Revised Front Bushings –
Revised Special Tools –
Replacement Procedure

MODEL
1997 MY-ON XK8 Range
1998 MY-ON V8 XJ Series
VIN
001001-ON
812256-ON

Remove and destroy Bulletin 204-11, dated 02/00.
Replace with this Bulletin.
Revisions are marked with a bar and in **bold text**.

ILLUSTRATION 1

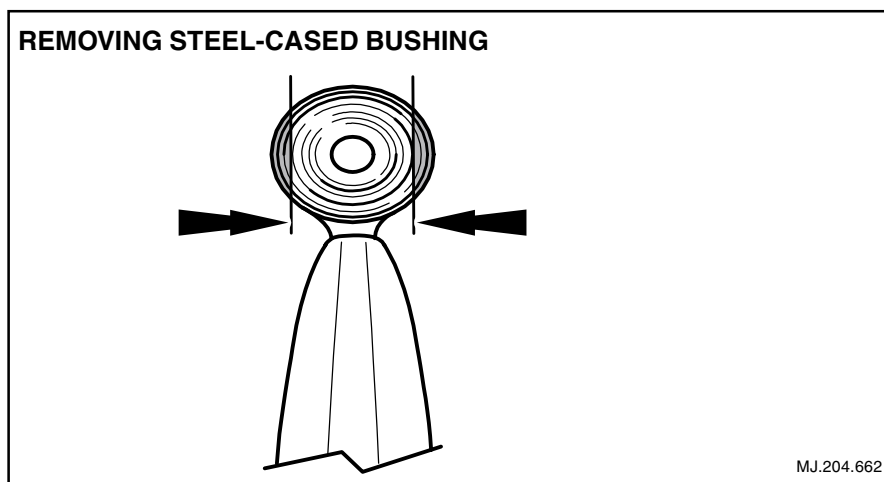
REMOVAL OF STEEL-CASED BUSHINGS (LATER DESIGN)

1. Make 2 sawcuts through the rubber and **partly** into the flange of the steel casing, at the locations shown in Illustration 1, in line with the casing of the bush.

⚠ Caution: Do **not** cut **fully** through the steel flange. The sawcuts should penetrate through only 75 - 80 % of the thickness of the steel flange, so that the wishbone arm is **not** touched by the saw blade.

ILLUSTRATION 2

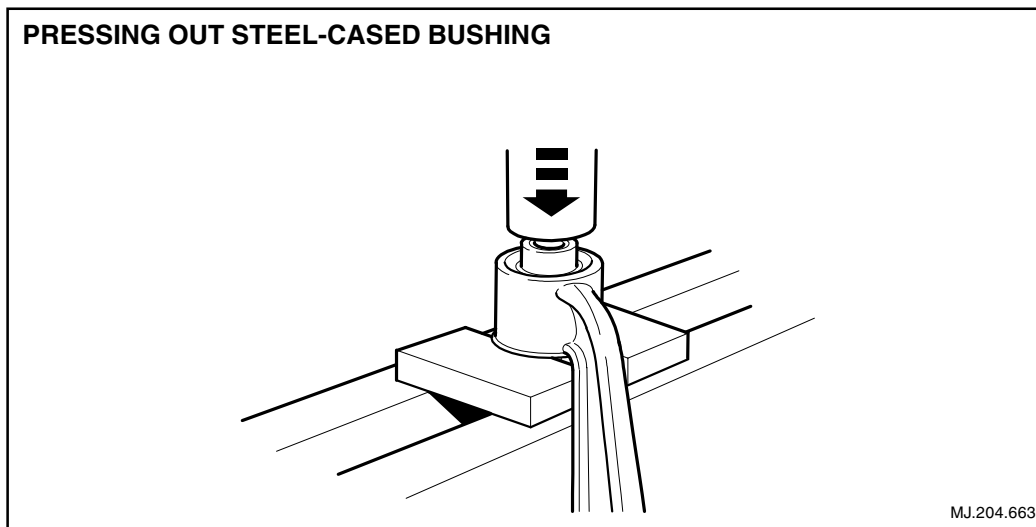
3. Position the wishbone arm on the support plates of the hydraulic press, so that the bushed end is supported by the plates where the 'half-moons' have been removed, allowing the casing of the displaced bush to pass between the support plates. See Illustration 2. (Front arm illustrated - rear arm similar).
4. Using Special Tool 204-214, press the bush from the bore in the wishbone arm.
